Access Compliance Report

Public Rights-of-Way

Intersection ID: 8569	Main Street: PENNY_WY	Cross Street: W_SUGAR_CREEK_RD	Location: NE
ADA ID: F8FDCC8C6E63	Ramp Type: PerpDiag	Initial Pass/Fail: Pass	Overall Compliance: No
Severity Score: 0.25			
Codes/Mitigation Info/Possible Solution		Field Measurements/Component Compliance

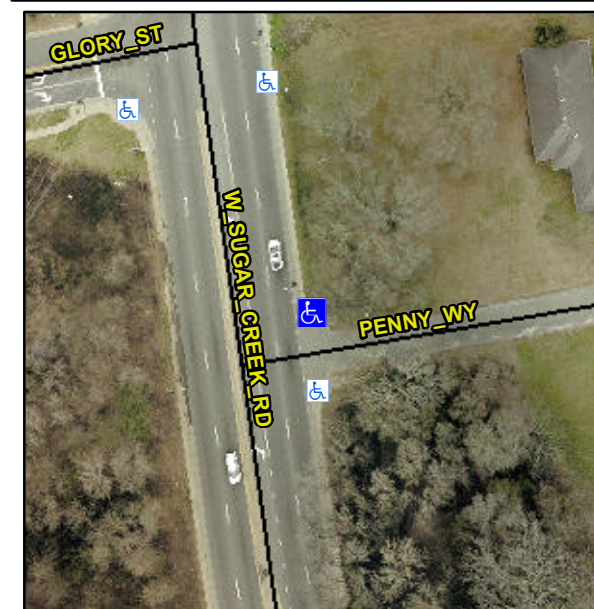
Not Found, R304.5.3, R304.2.1, R304.2.2-Perp, R304.3.2-Para

Compliance	Description	Data	Compliance	Description	Data
N/A	Ramp Length (in)	25.0	Yes	Ramp Slope (%)	5.3
Yes	Ramp Width (in)	48.0	No	Ramp XSlope (%)	3.8
N/A	Flare Type LT	Sloped	N/A	Flare Type RT	N/A
N/A	Flare Slope LT (%)	14.4	N/A	Flare Slope RT (%)	1.3
N/A	Flare Traversable LT?	No	N/A	Flare Traversable RT?	No
No	Landing Length (in)	26.0	Yes	DWS Provided?	Yes
Yes	Landing Width (in)	48.0	Yes	DWS Contrast?	Yes
No	Landing Slope (%)	2.9	Yes	DWS Length (in)	24.5
No	Landing X Slope (%)	4.4	Yes	DWS Full Width?	Yes
N/A	Landing Curb? (Y/N)	No	Yes	DWS Offset (in)	0.5
N/A	Shared Landing?	No			
Yes	Gutter Ponding?	No	Yes	Gutter Slope (%)	4.5
Yes	Gutter Lip Ht (in)	0.0	No	Gutter X Slope (%)	5.2
N/A	Painted X Walk1?	No	N/A	Painted X Walk2?	No
	X Walk 1 Direction	To W		X Walk 2 Direction	To S
N/A	X Walk 1 Width (in)	N/A	N/A	X Walk 2 Width (in)	N/A
	X Walk 1 Slope (%)	5.4		X Walk 2 Slope (%)	1.1
	X Walk 1 X Slope (%)	0.3		X Walk 2 X Slope (%)	6.6

Remove & Replace Curb Ramp With Two New Directional Ramps or Equivalent. Remove & Replace Gutter.
